The Technical Specifications contained in Appendices A and B, as revised through Amendment No. 281, are hereby incorporated into this license. The licensee shall operate the facility in accordance with the Technical Specifications.

The Technical Specifications contained in Appendices A and B, as revised through Amendment No. 258, are hereby incorporated into this license. The licensee shall operate the facility in accordance with the Technical Specifications.

Figure 3.4.15-1 (page 1 of 1)
Reactor Coolant DOSE EQUIVALENT I-131 Specific Activity Limit
Versus Percent of RATED THERMAL POWER With Reactor Coolant
Specific Activity $\geq 0.5 \mu\text{Ci/gm}$ DOSE EQUIVALENT I-131

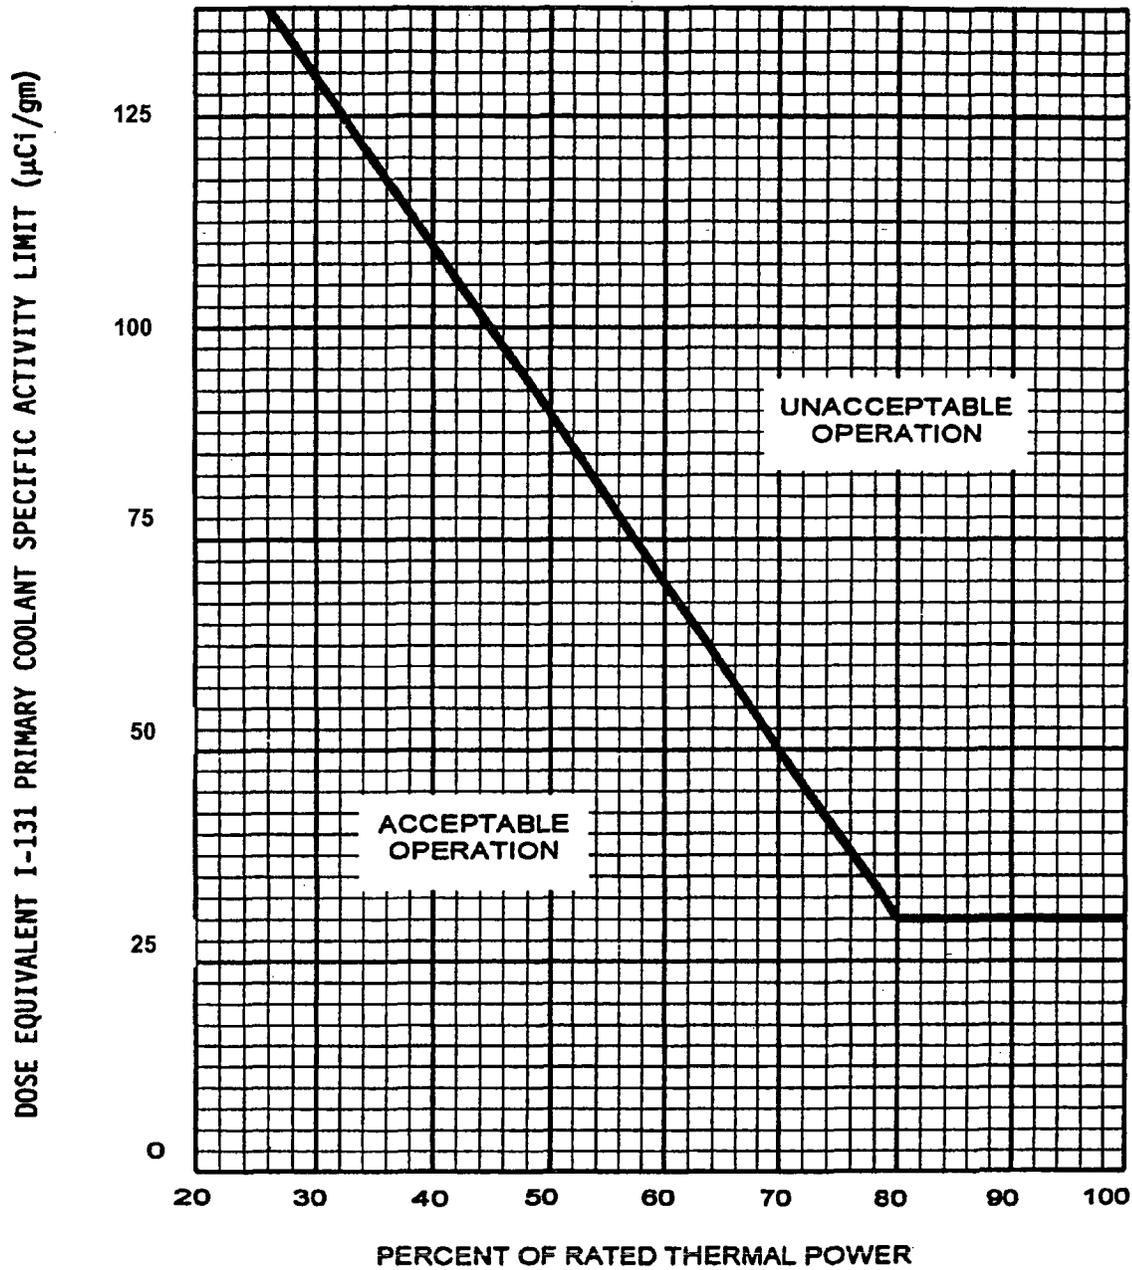
CONDITION	REQUIRED ACTION	COMPLETION TIME	
<p>A. DOSE EQUIVALENT I-131 > 0.5 μCi/gm.</p>	<p>----- NOTE ----- LCO 3.0.4.c is applicable. -----</p>		
	<p>A.1 Verify DOSE EQUIVALENT I-131 within the acceptable region of Figure 3.4.15-1.</p>		<p>Once per 4 hours.</p>
	<p><u>AND</u> A.2 Restore DOSE EQUIVALENT I-131 to within limit.</p>		<p>100 hours</p>
